Docket Item # 1  
BAR CASE #2010-0325

BAR Meeting  
January 19, 2011

**ISSUE:** Signage  
**APPLICANT:** CHLN, Inc. (Chart House Restaurant)  
**LOCATION:** 1 Cameron Street  
**ZONE:** CD / Commercial

**BAR CASE #2010-0325**

Figure 7. Revised details for illuminated sign on west elevation.

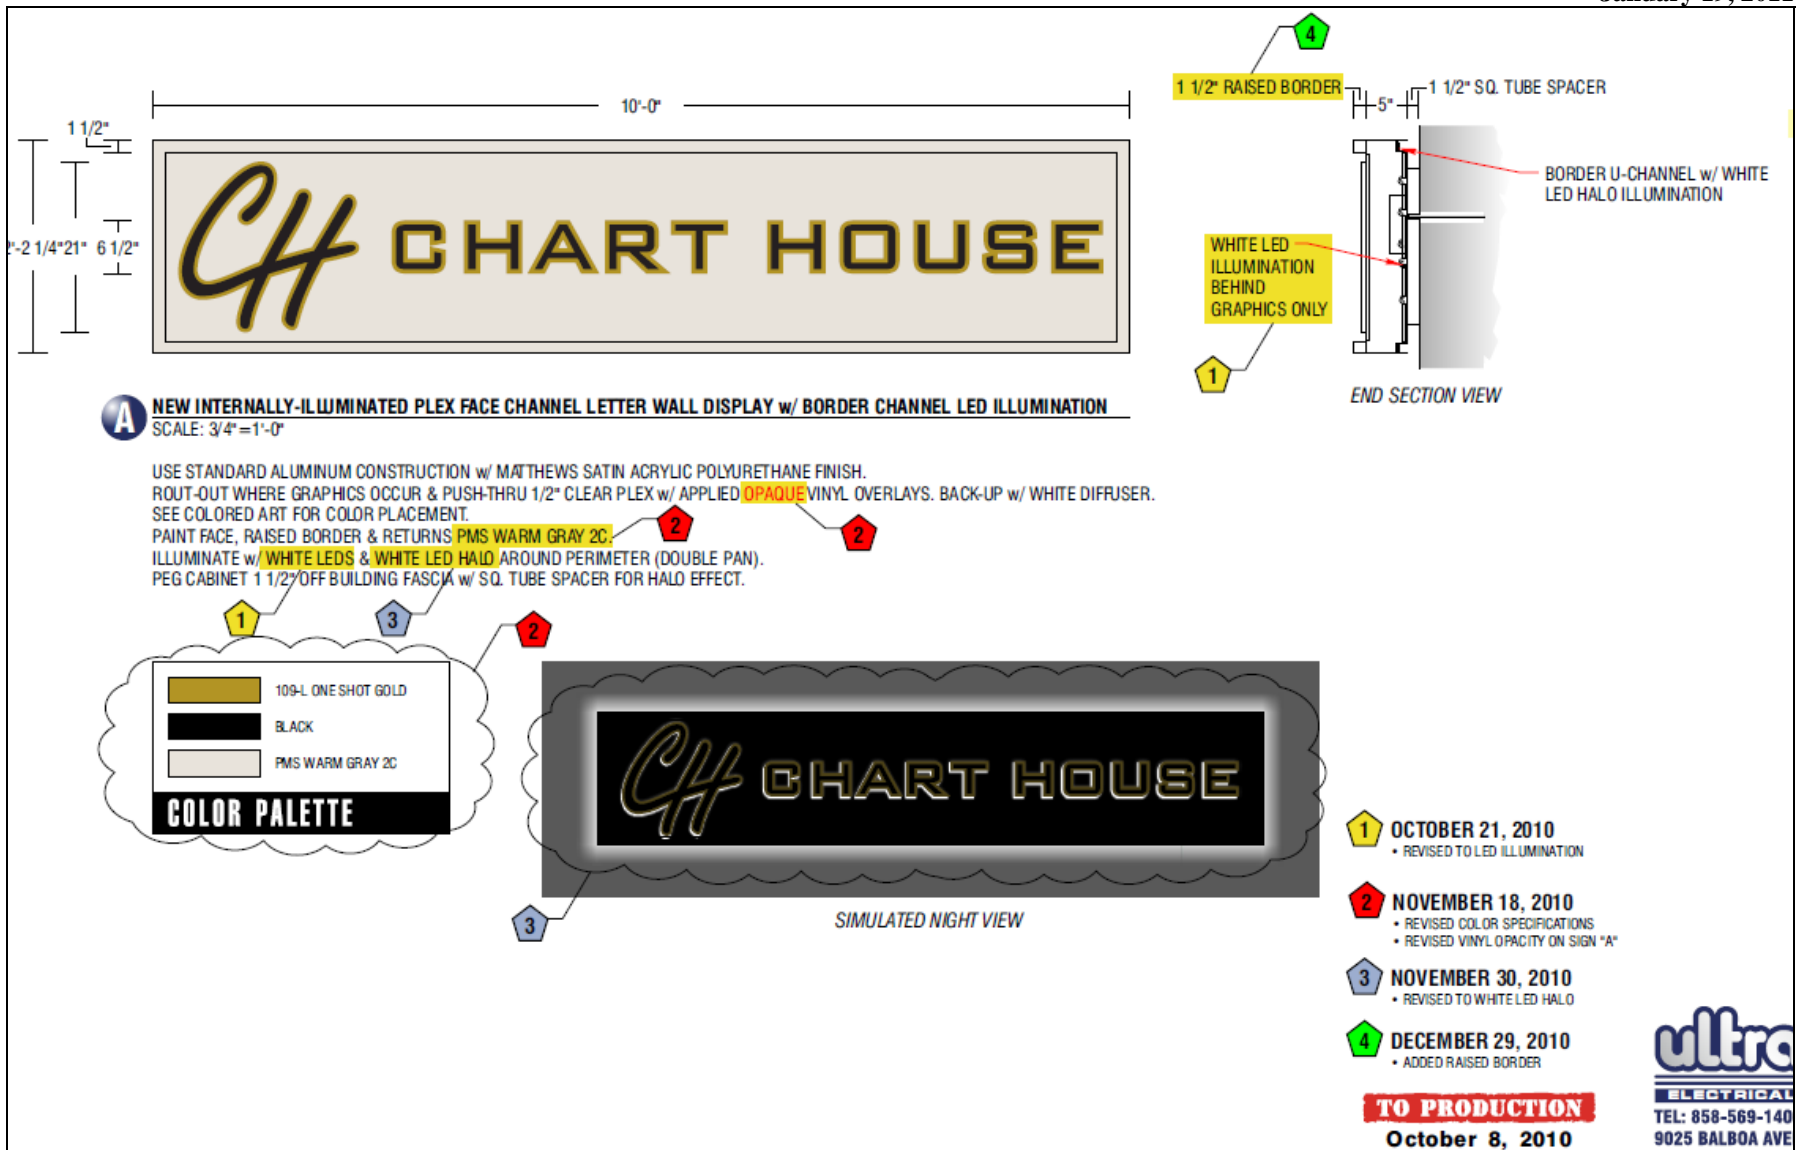
Mr. Smeallie noted that the revised designs are an improvement from the original application submittal presented to staff. Yet, he encouraged the applicant to re-study the lighting for the sign. He objected to the halo style lighting and recommended more traditional “gooseneck” lights, which are a common historic fixture within the district.

Mr. Neale concurred with Mr. Smeallie and preferred the more traditional style lighting. He also recommended that the applicant consider surrounding the sign with a wood “picture frame” to have it complement the existing architecture.

Mr. Fitzgerald moved approval of the application, with the conditions that the large signs be surrounded with a molded frame and lit from above with gooseneck lighting.

At the December 15, 2010 BAR hearing, the Board approved replacement signage for the Charthouse with the conditions that a wood frame be added around the signs and that the proposed internal illumination on the main sign be replaced with gooseneck light fixtures for external illumination. Because the Board approved the application (with conditions), the applicant was unable to appeal the Board's decision to City Council, and requested that the Board reconsider the application. In response to the Board's request the applicant added a raised border to frame the sign, as shown in the revised drawing. The applicant continues to request the internally illuminated channel letters with halo backlighting, similar to what is currently installed. Changes to the application are noted in **bold** in the report.

*NOTE:  
EXTERNAL ILLUMINATION BY OTHERS.*
